UNITED STATES PATENT AND TRADEMARK OFFICE

APPLICATION NO.	FILING DATE	FIRST NAMED INVENTOR	ATTORNEY DOCKET NO.	CONFIRMATION NO.
10/667,115	09/19/2003	Russell Norman Mirov	SUN03-0112	8531
57960 7590 06/12/2009 PVF -- SUN MICROSYSTEMS INC. C/O PARK, VAUGHAN & FLEMING LLP 2820 FIFTH STREET DAVIS, CA 95618-7759				
EXAMINER				
DINH, TUAN T				
ART UNIT		PAPER NUMBER		
2841				
MAIL DATE		DELIVERY MODE		
06/12/2009		PAPER

Office Action Summary

DETAILED ACTION

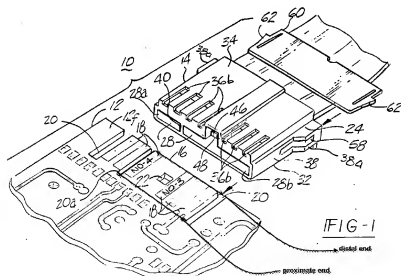
5. Claims 1-2 are rejected under 35 U.S.C. 102(b) as being anticipated by Matson et al. (U.S. Patent '112) as in the record.

As best understood to claims 1-2, Matson discloses a circuit board (12, column 2, line 7) as shown in figures 1-2 comprising: a substrate which includes a specified area of the substrate that is used as a mechanism (16, column 2, line 9) comprising:

signal means for (wire traces 18, and circuitries formed in/on the circuit board 12) conducting a signal between the mechanism (16) and the circuit board (12), the traces being routed on the mechanism; and

separation means (gaps 20, column 2, line 15) for facilitating detachment of the mechanism (16) from the circuit board (12) wherein the mechanism (16) **is configured to be** detached by breaking the substrate at the specified area (the mechanism adapted to be broke then the circuit board being broke then the circuit board cannot be used anymore);

identification means for (labels No.1-No.6, figure 1 shows the label No.3 and No.4) identifying the mechanism (16);

wherein the circuit board becomes at least partly non-functional if the mechanism is detached from the circuit board.
